**Public Service
of New Hampshire**

Subject: Schiller Station NPDES Permit No. 0001473
Unit 4 Intake Structure

- 9900-1: Location of Existing Intake Structures
- 544-36: Design and Proposed Modification to Unit 4 Intake

- 592-B-3: Inner Trash Racks Location
- 592-B-10: Trash Racks Design

T7-3	
<h1>DETAILS OF INTAKE PIPES SCREEN HOUSE PORTSMOUTH STEAM PLANT PUBLIC SERVICE COMPANY OF NEW HAMPSHIRE</h1>				
VISION		DATE	CHKD	
8/12/02		7-14-48	B.W.F.	
		6-29-48		
		4-25-48		
CHKD.		NEPSCO SERVICES, INC. ENGINEERING DEPARTMENT		544-36
APPR.		SCALE SHOWN		
		DATE 6-21-48

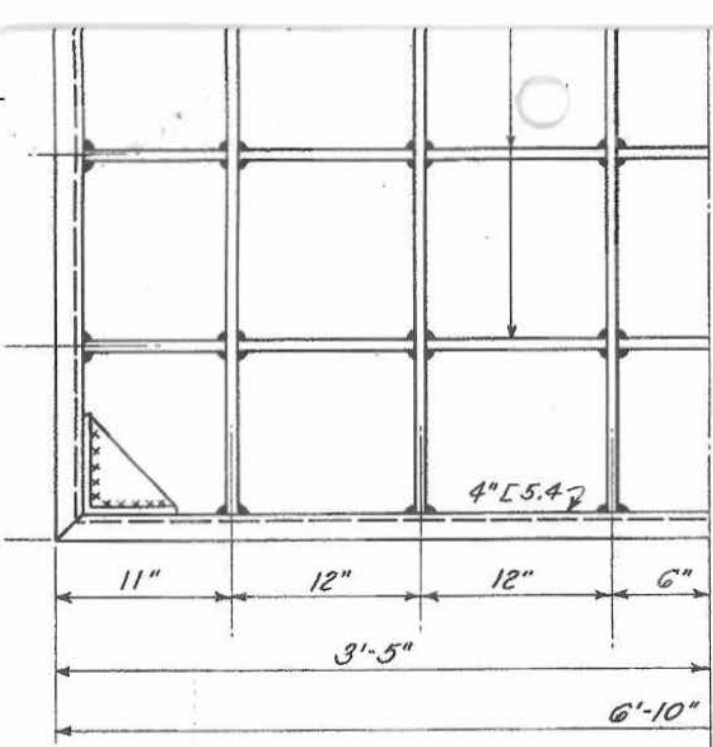
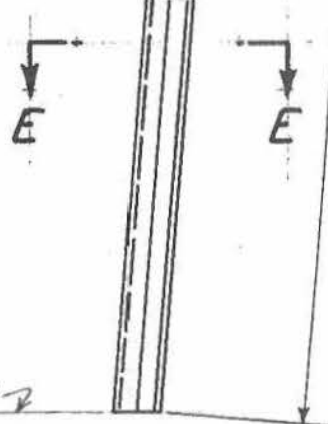
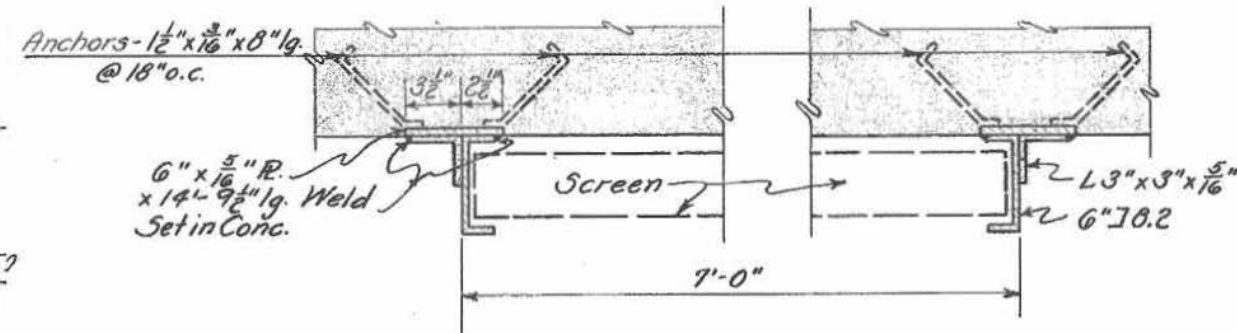
EPA has previously determined that the circulating water intake structures at Schiller Station employ the best technology available for minimizing adverse environmental impact. In accordance with Part I, Section A.1.f. of the Schiller Station NPDES Permit, PSNH is requesting approval to modify the intake structure of Unit 4. Partly because the actual intake box is located approximately 30 feet offshore, the unit has historically impinged a higher rate of lobsters than the other two operating units. To help mitigate lobster impingement, PSNH proposes to install a steel framed fiberglass screen across the intake structure along the bottom of the river. The screen will attach to the existing trash rack guides with 2-inch angle iron and will extend approximately four feet up from the river bottom. The screen interior will be constructed of 1-1/2-inch fiberglass mesh, anchored by two 3-inch stainless steel corner posts. The following drawings are enclosed to show the project details:

7/11/51	4-6-51	PUBLIC SERVICE CO OF NH SCHILLER STATION PROJECT	
11/5/51	4-5-51	JACKSON & MORELAND, ENGINEERS BOSTON - NEW YORK	
11/5/51	4-5-51	SCREEN HOUSE SUBSTRUCTURE	
N.H. 1951		CONCRETE OUTLINE - PLANS & SECTIONS	
RECORD NUMBER		SCALE	
4592		Unless otherwise Noted 1/4" = 1 FOOT	592-B-3

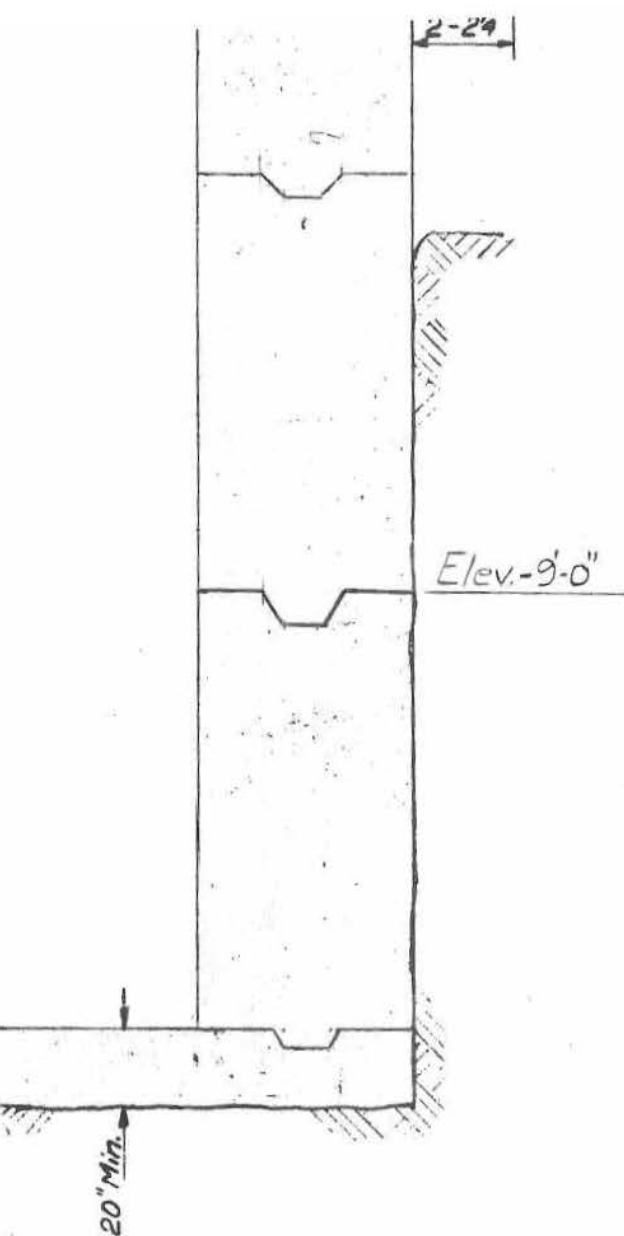
In addition to this change, PSNH requests approval to remove a second set of trash racks located within the actual screenhouse. In this interior location, there is no easy method to clean debris from the racks due to a lack of accessibility. These inner racks are a redundant feature and were made obsolete by the presence of the outer trash racks referenced above. Any material that passes by the outer trash racks is captured by the finer mesh rotating screens positioned downstream. The efficiency of the generating unit will be improved by the removal of the racks as cooling water will not be impeded as the racks become blocked. The following drawings are enclosed to show details of the racks:
